**City of Fairhope
Planning Commission Agenda
5:00 PM
Council Chambers
June 3, 2024**

SR 24.02 - Thomas Hospital NW Addition Site Plan

SD 24.14 - Highlands at Fairhope Village Phase 2 MOP

Figure 4- 2. Parking drive aisle widths may vary depending on the configuration and angle of parking that the drive aisle supports.

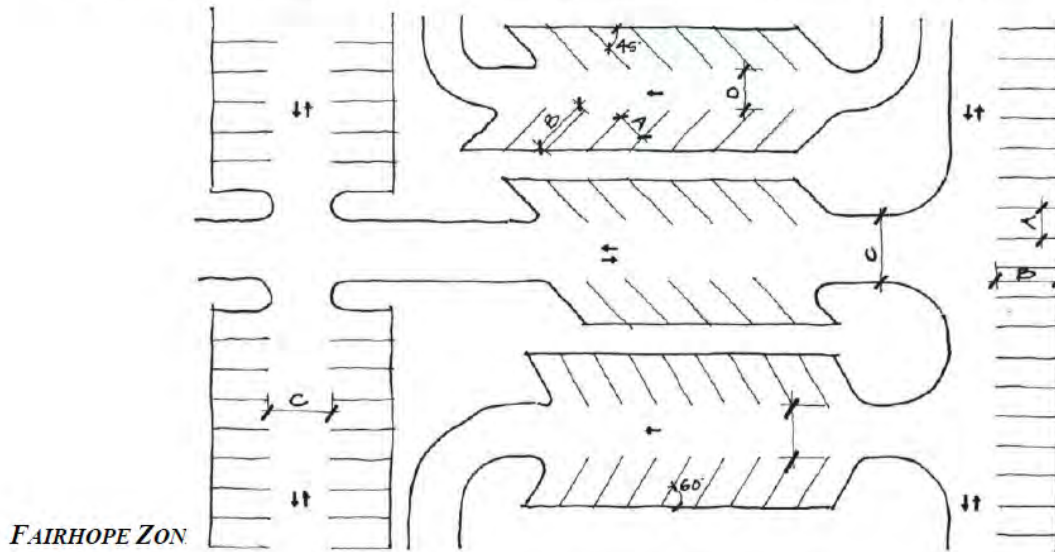
The proposed stalls do not meet the standard parking dimensions in at least width because the stalls are supposed to be 10 ft wide; whereas the proposed stalls are 9 ft wide. *See below.* Staff requested an explanation for the proposed parking and why it does not meet the parking requirements on May 9, 2024. *See DRC letter in the packet.*

Figure 1: Sheet C200 snippet 1.

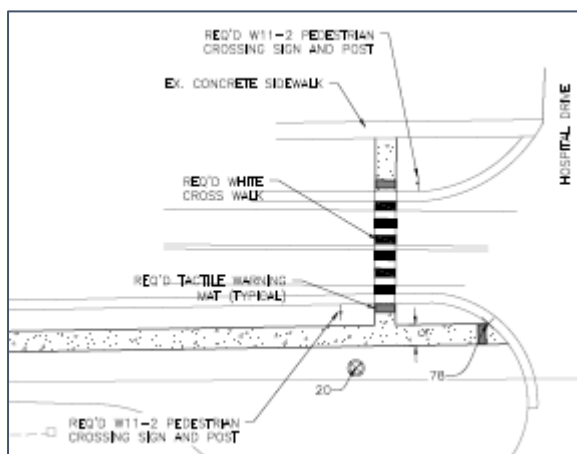
Sidewalks: This Site Plan includes sidewalks on Morphy Ave that shall extend to Hospital Dr and on the eastern side of S. Ingleside Avenue. There will be a new crosswalk installed at Hospital Drive and Morphy Avenue. Staff questions whether a signalized crosswalk is desirable at the mid-block Ingleside crosswalk.

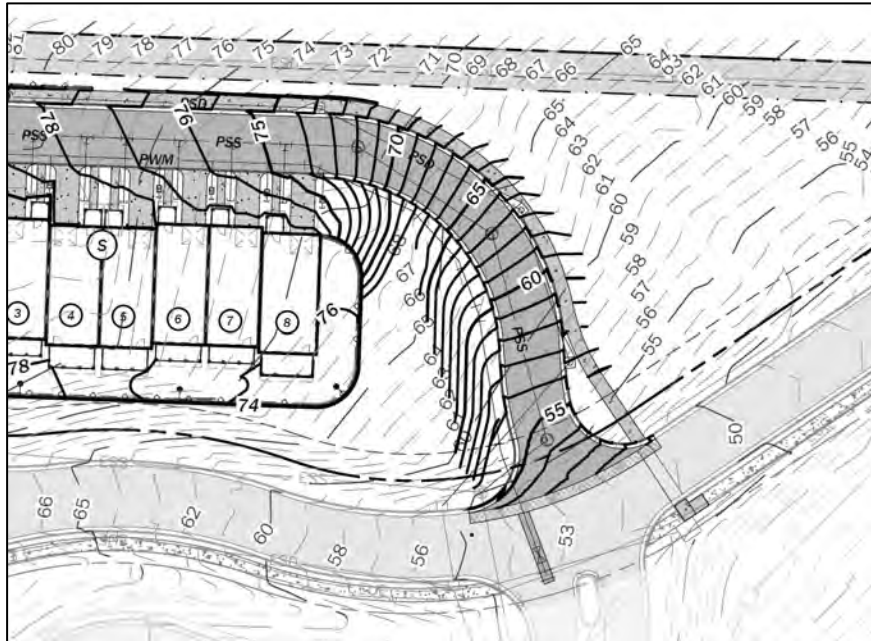
Within the remaining 5 ft of the buffer, landscape and fencing are proposed. The Civil plans note that a 4’ vinyl-coated chain link fence is allowed at the owner’s discretion. However, an 8’ opaque fence is required, along with a hedge row per the Tree Ordinance and Zoning Ordinance. Revised landscape plans shall be submitted to Staff for review prior to applying for a building permit.

In addition, grading plans illustrate some steep slopes with nothing but seed currently proposed. One such area is highlighted in the below illustration. Staff recommend additional planting along these slopes to help stabilize the embankments.

Pedestrian Circulation Plan

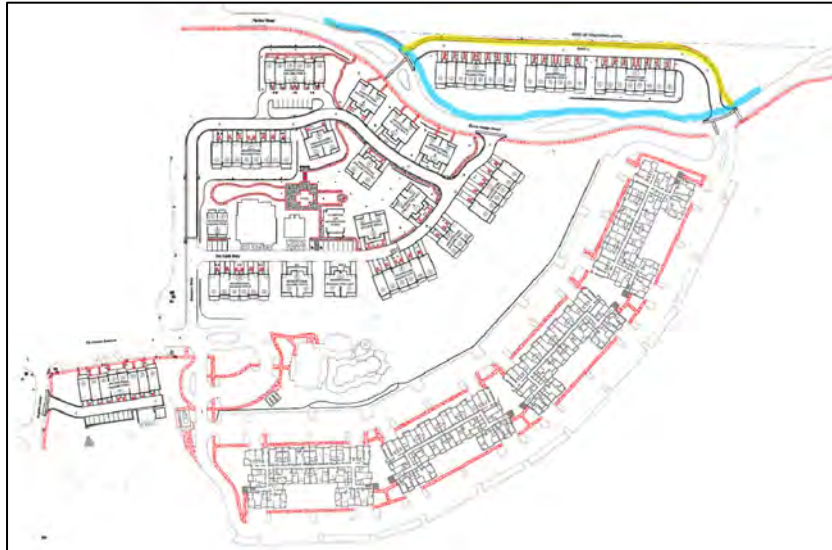
The below pedestrian circulation plan was submitted with this application. Note that this plan also includes the sidewalks installed with the Retreat at Fairhope Village. The most recent PUD amendment illustrated a sidewalk in the approximate location of the blue line below. Due to the topography, the applicant has proposed the sidewalk atop the hill near the north property line. Staff feels this is too close to the required buffer and is not functional to connect to the future development eastward. The proposed sidewalk would be on private property, not the City right-of-way.

The following plan was submitted with the 2016 Fly Creek PUD Amendment (ZC 16.02). As illustrated with the magenta lines, there were proposed sidewalks connecting the various areas of the PUD by way of the common areas/woodlands. The sidewalks highlighted below have not been installed. It is also important to note there was no sidewalk proposed along the north side of Corte Ridge Rd. on this plan. As an aside, the white circle highlights a amenity structure proposed on the Master Plan.

Staff feels the original plan offered better connectivity. In lieu of the sidewalk on the north side of Corte Ridge Rd, the sidewalks as originally proposed be installed to offer connectivity from future developments to Fly Creek Ave. Schematically, the below sketch would result in a sidewalk network below. Blue lines ensure connectivity among the various phases of the PUD, while green lines represent the sidewalks within each phase of the PUD. Staff recommends the blue lines have a public access easement.

1. Site Plan shall cross reference the architectural elevations.
2. Pedestrian Circulation Plan shall be amended to reflect Staff recommendations. *As an alternative, Planning Commission may amend the Staff recommendation.
3. Additional plantings shall be required within the 10' buffer where the townhomes (residential) lot abuts the fire department (incompatible uses) to ensure there is a visual screen.
4. Revised landscape plans shall be submitted to staff review prior to application of a building permit.
